BEFORE THE PUBLIC UTILITIES COMMISSION OF THE STATE OF CALIFORNIA

Application of the Alameda Corridor – East Construction Authority (ACE) for an order authorizing elimination of an existing at-grade crossing through construction of a grade separated crossing (roadway underpass) at Nogales Street, under Union Pacific Railroad Company’s Alhambra Subdivision main line, in the City of Industry, County of Los Angeles.

Application 02-01-038
(Filed January 31, 2002;
Petition for Modification filed
September 9, 2003)

OPINION MODIFYING DECISION 02-11-012**Summary**

DETOUR ROAD GRADE CROSSING

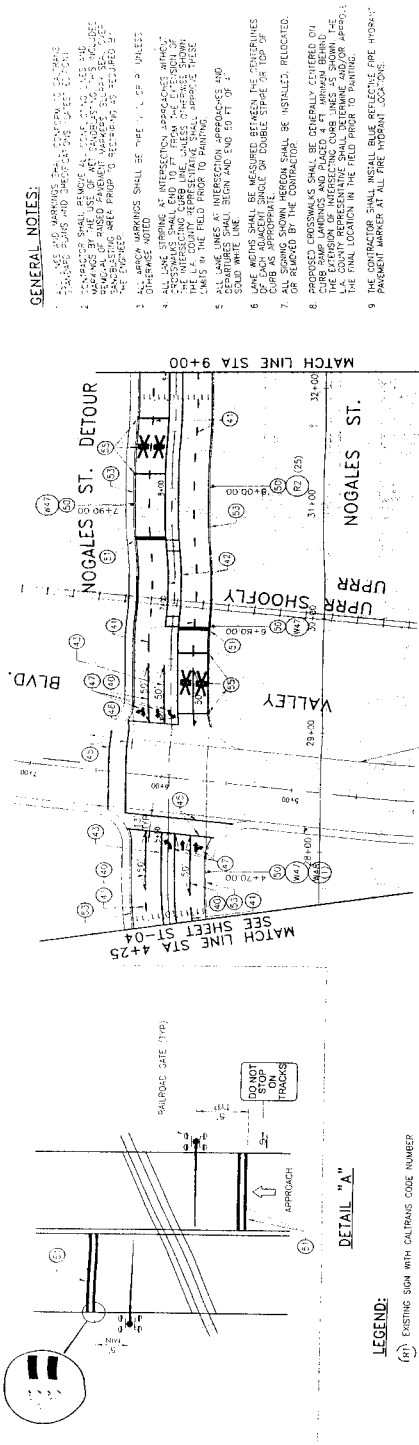
ACE filed the Petition for Modification of D.02-11-012 on September 9, 2003, to request a substitution to the type of warning devices at the proposed temporary detour at-grade highway-rail crossing. In A.02-01-038, ACE requested and in Ordering Paragraph 5 of D.02-11-012, the Commission ordered the installation of two CPUC Standard No. 9-A (flashing light signals with automatic gates with additional flashing lights on cantilevered mast arms, as defined in Commission General Order (GO) 75-C) warning devices and two CPUC Standard No. 9 (flashing light signals with automatic gates, as defined in GO 75-C) warning devices. In this Petition for Modification, ACE requests authority to install two CPUC Standard No. 9 and two median-mounted CPUC Standard No. 9 warning devices in lieu of the warning devices ordered in D.02-11-012.

2. The warning devices specified in D.02-11-012 are two CPUC Standard No. 9-A and two CPUC Standard No. 9 warning devices. The warning devices specified in this Petition for Modification are four CPUC Standard No. 9 warning devices (two warning devices located on the curbsides and two warning devices located on raised median islands).

1. Ordering Paragraph 5 is revised to read as follows: Alameda Corridor – East Construction Authority (ACE) shall install at the temporary detour at-grade highway-rail crossing, identified as CPUC Crossing No. B-504.87, four CPUC Standard No. 9 (flashing light signals with automatic gates, as defined in Commission General Order (GO) 75-C) warning devices (two warning devices on the curbsides and two warning devices each located on a raised median island), substantially as shown by plans attached to the Petition for Modification and Appendix of this order.
2. In all other respects, D.02-11-012 shall remain in full force and effect.
3. The Petition for Modification is granted as set forth above.
4. Application 02-01-038 is closed.
